GULF STATES UTILITIES COMPANY

December 30, 1983
RBG- 16,670
File No. G9.5, G9.8.6.2

River Bend Station Units 1 & 2
Docket Nos. 50-458/50-459

Enclosed are Gulf States Utilities Company's (GSU) responses to the items identified by reviewers from the Environmental and Hydrological Engineering Branch (EHEB) in the Draft Safety Evaluation Report (DSER). The Nuclear Regulatory Commission (NRC) Staff indicated on DSER Pages 2-40 and 2-42 (Sections 2.4.8.2 and 2.4.10 respectively) that groundwater levels which were used in combination with other environmental loads must be identified. The Final Safety Analysis Report (FSAR) establishes normal and maximum groundwater evaluations in Section 2.4.13.5, while loads and loading combinations are described in Section 3.8.4.3. Also, the DSER identified in Section 2.4.10, Page 2-42, disagreements on the appropriate Design Basis Flood Level (DBFL) for flooding from local intense precipitation on West Creek and the plant site drainage system. GSU has reviewed Hydrometeorological Report No. 52 and River Bend Station (RBS) assumptions and conservatisms used to determine the DBFL.

PLANT DRAINAGE AREA BOUNDARY

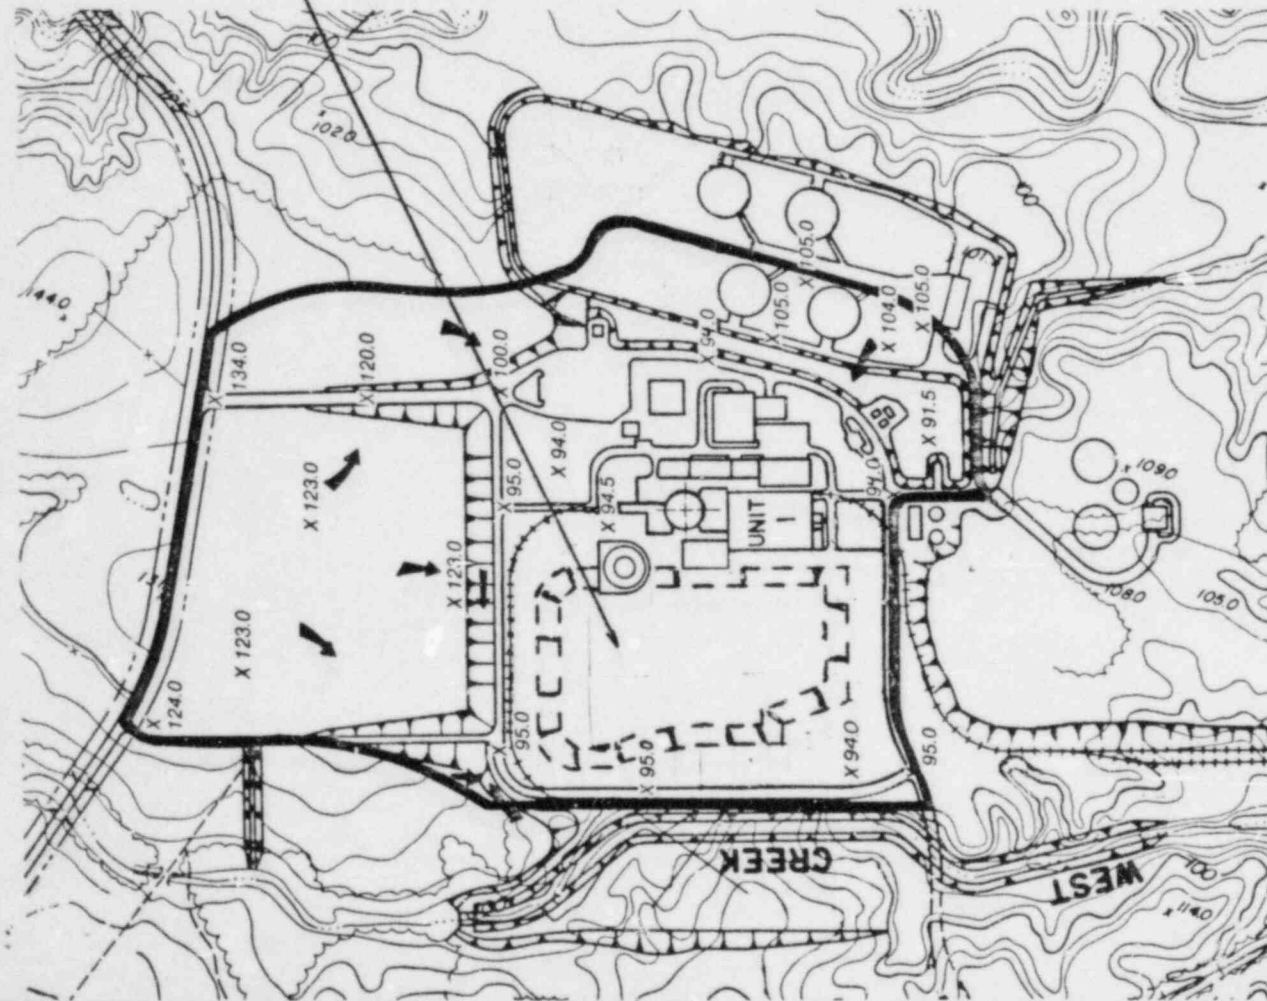
The characteristics of the site drainage network is highly dependent on grading and railroad track rail elevations. Provide detailed drawings of drainage areas that includes ponding locations, direction of flow, and a profile of the top of railroad track steel rails.

REPLACE WITH THE ATTACHED FIGURE.

The response to this request is provided in revised Section 2.4.2.3 and new Fig. 2.4-6a.

revised Figure 2.4-6.

FIGURE 2.4-22

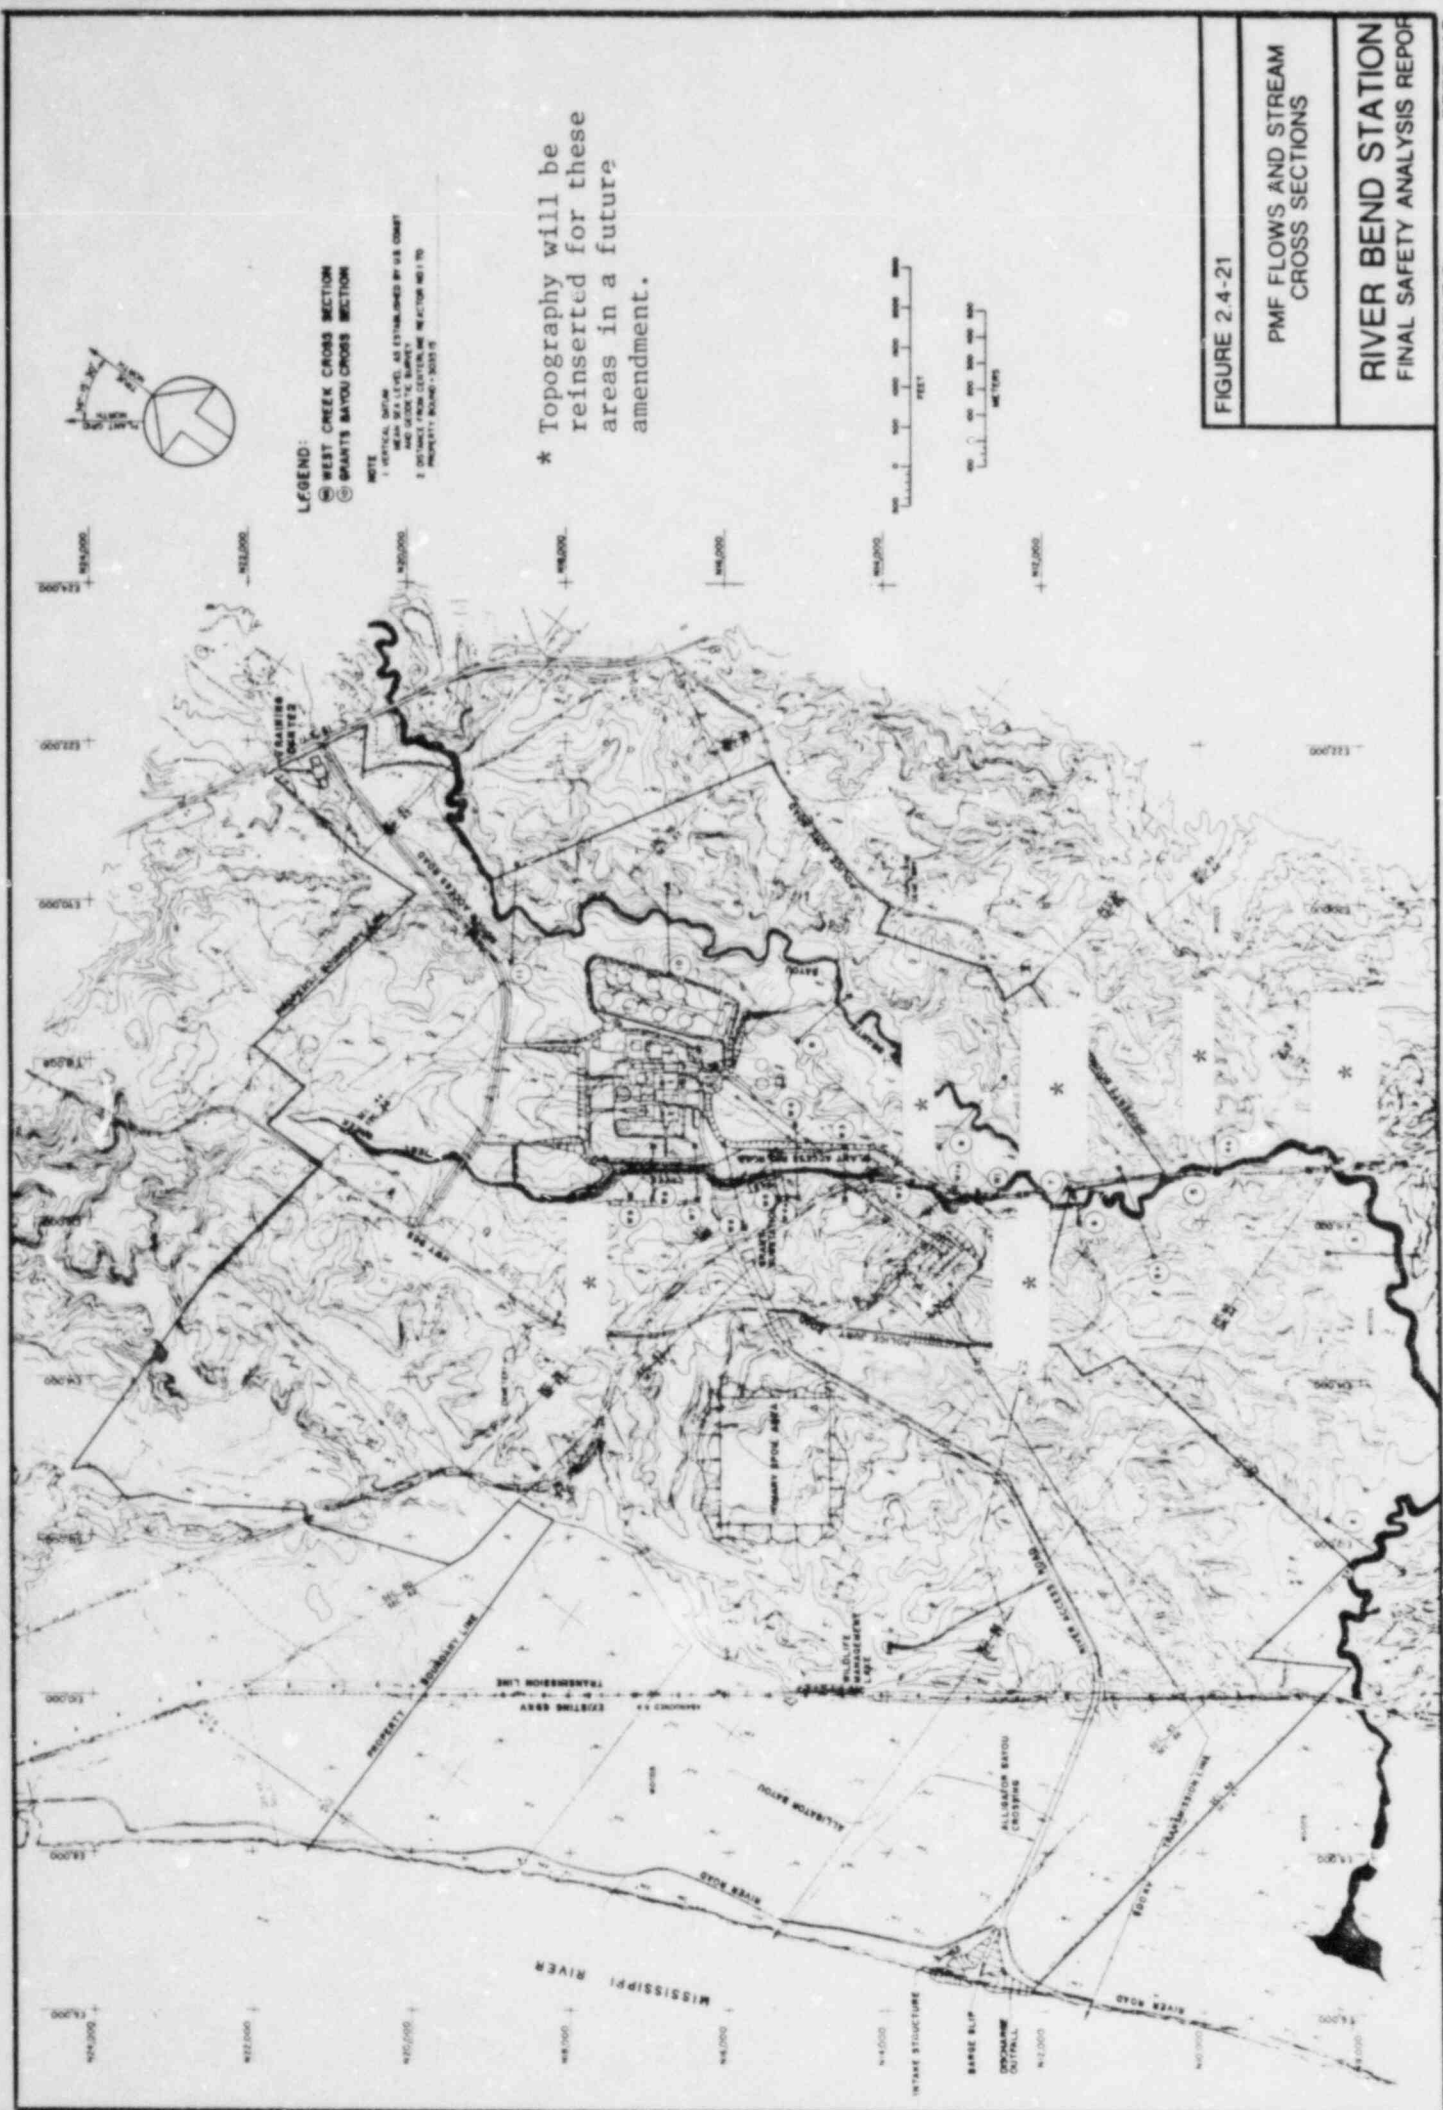
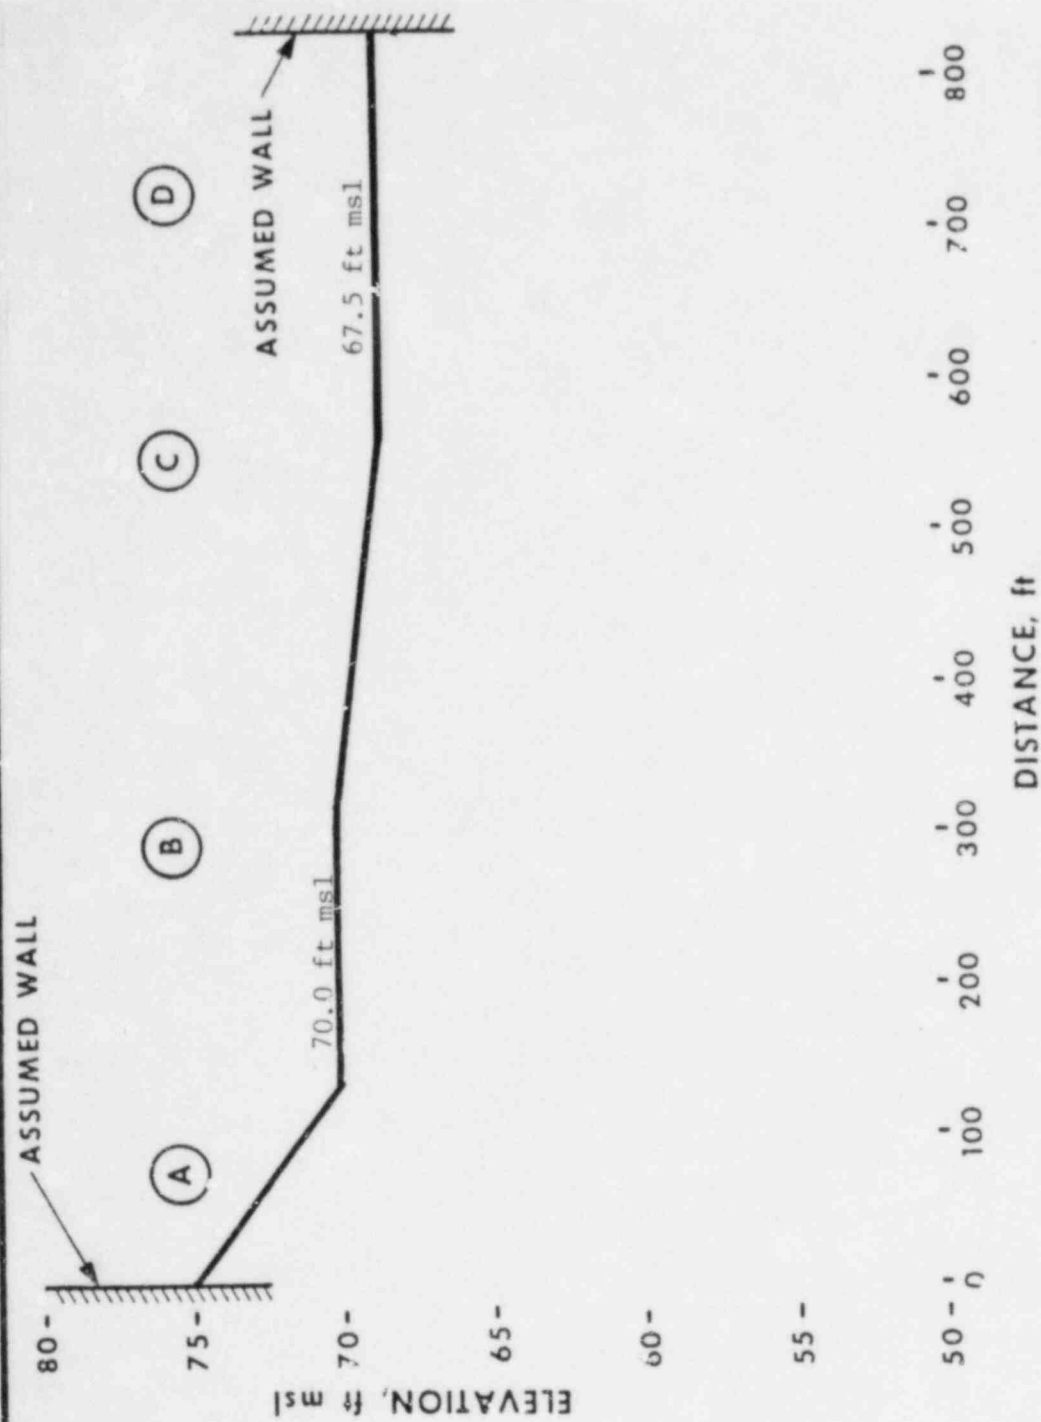
At the construction permit stage the results of the analysis of flood conditions on West Creek indicated the peak water level could reach an elevation of 98.49 ft MSL. It is stated in Section 2.4.2.2 of the FSAR that the maximum water elevation that would be produced is 95.1 ft MSL. Also, the SER for the construction permit stage discussed a PMF peak discharge of 5460 cfs for West Creek. Section 2.4.3.4.2 of the FSAR indicates a West Creek PMF of 4000 cfs. Provide a detailed discussion of the reasons for the modifications in water surface elevation and PMF discharge estimates. The data to be provided in your discussion should include channel cross sections, assumptions, and calculations to allow for an independent staff evaluation.

The assumptions and calculations of the latest PMF are discussed in Section 2.4.3. The locations of the cross sections used in the determination of the surface water elevations are shown in Figure 2.4-21. The detailed data of these channel cross sections are presented in Tables 2.4-24 and 2.4-25 and Figures 2.4-22 through 2.4-28.
